GROUP	MODEL
ELE	2022-2024MY Soul (SK3)
NUMBER	DATE
402	October 2025

## TECHNICAL SERVICE BULLETIN

SUBJECT: **POWER WINDOW MAIN SWITCH REPLACEMENT (CA2510)**

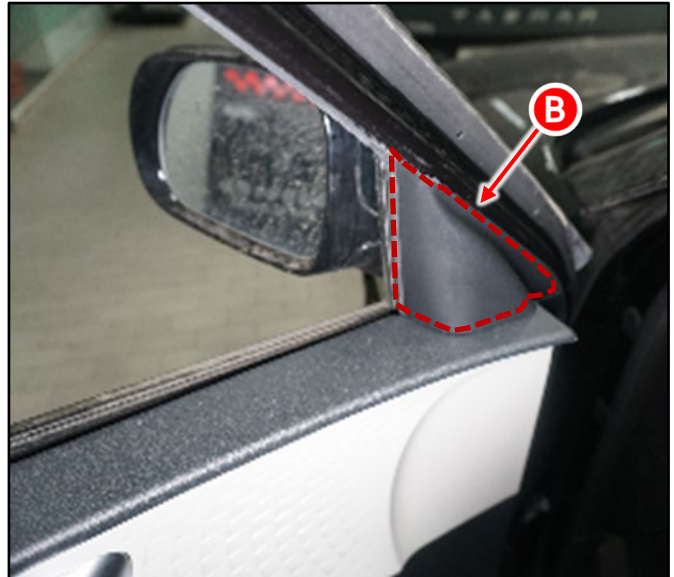
1. Disconnect the battery negative terminal after loosening nut (A).

Tightening torque for nut/bolt (X):  
5.8 - 7.2 lb.ft (7.8 - 9.8 N.m)

2. Remove the front door quadrant inner cover (B).

3. Remove the front door pull handle mounting cap (C).

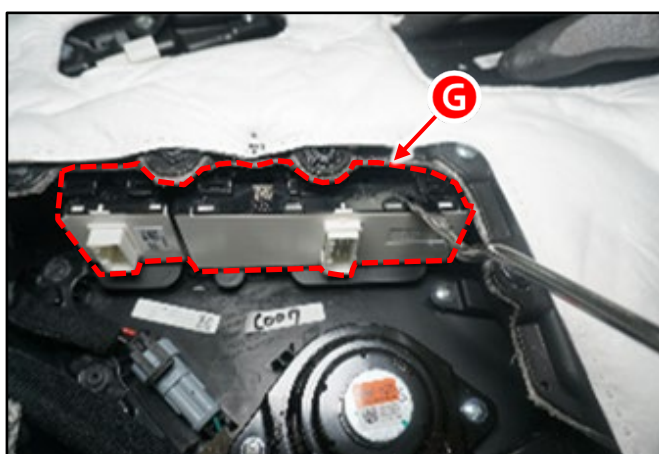
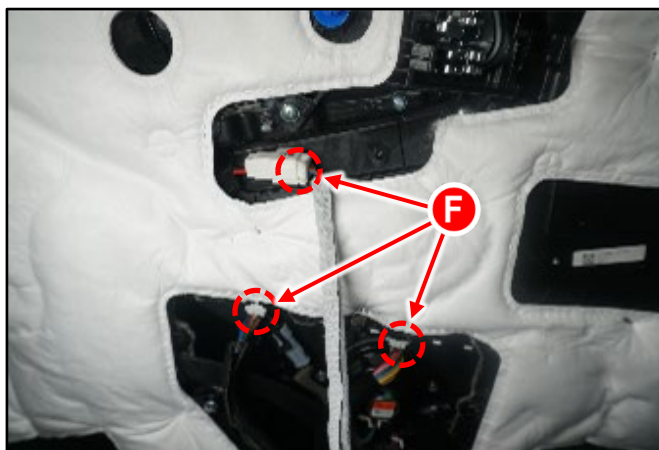
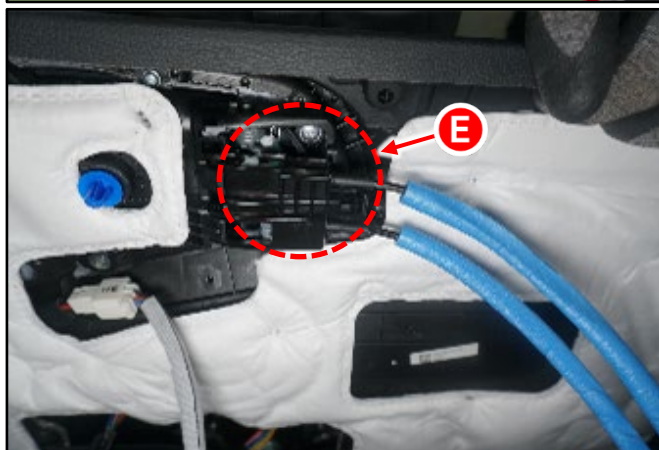
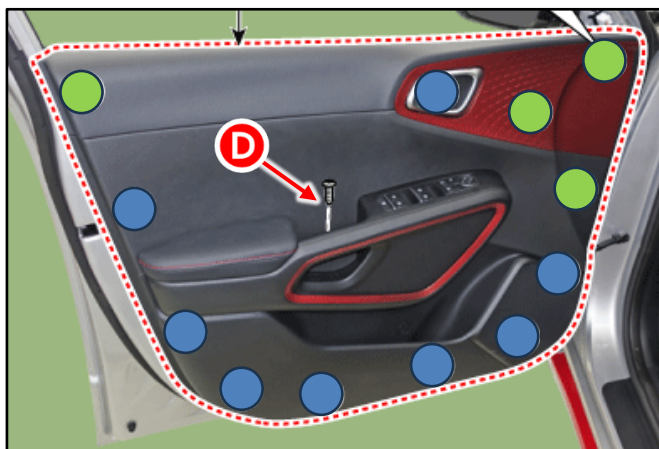
- Remove the driver's front door trim after loosening screw (D).

- Remove the door inside handle cable (E).

- Disconnect the front door trim connectors (F), 3EA.

- Remove the main power window switch and install the replacement switch.
